Keystone RV Company

SAFETY ADVISORY # 21-403

Cougar Inverter Wiring

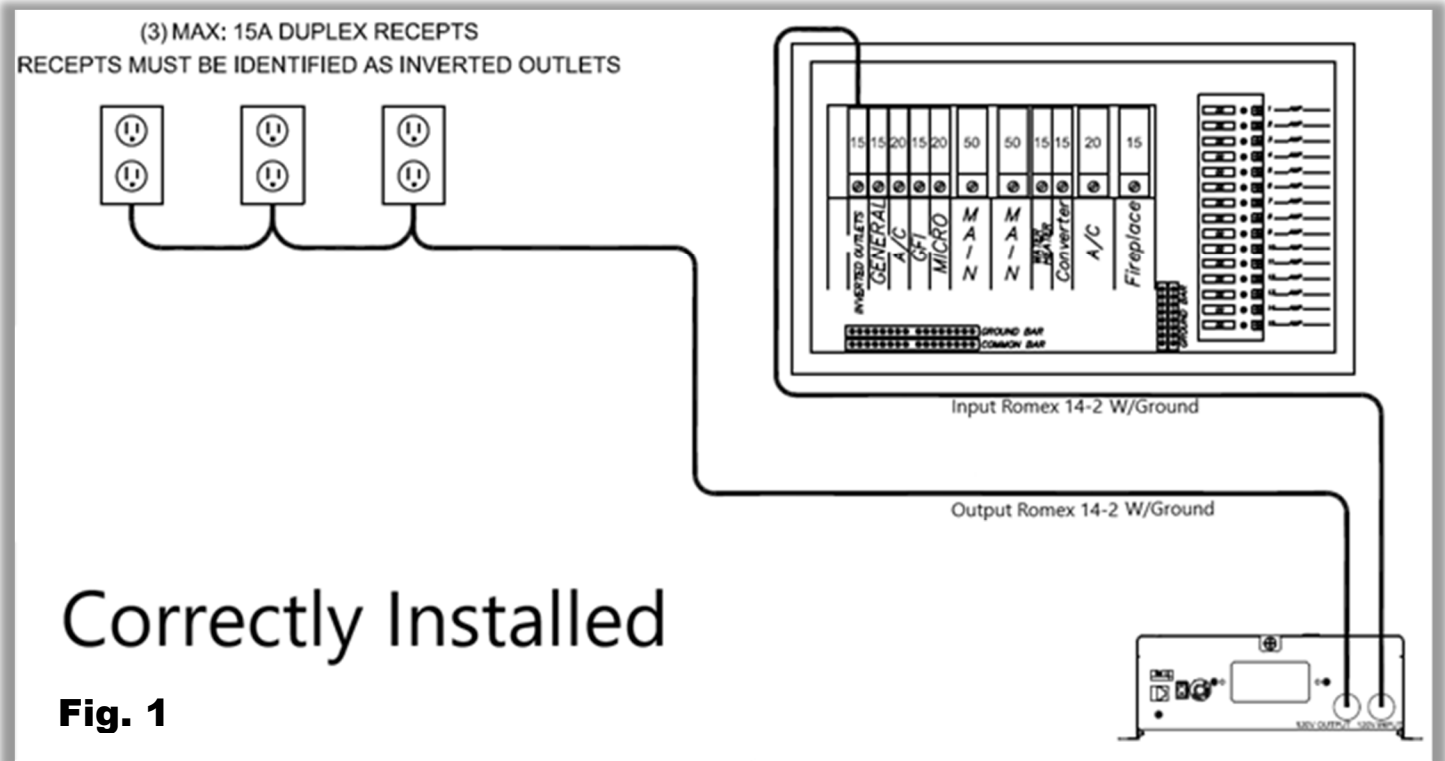
The remedy is to test the function of the inverter. The only outlets that should be energized are the outlets marked “Off the Grid Inverter Circuit”. If other outlets or appliances are energized the connection at the inverter must be inspected and repaired as needed.

With a fully charged battery connected; disconnect the shore power and turn on the inverter. Inspect outlets labeled "Off the Grid Inverter Circuit". These should be the only 120VAC circuits energized in the unit. See Figure 1. If these are the only circuits energized proceed to Warranty Reimbursement for inspection only, otherwise proceed to Step 3.

If other circuits are energized verify the inverter input and output connections are connected properly. If the connections are reversed, disconnect 120VAC and 12VDC power to the unit, repair the connections and test the function of the inverter.
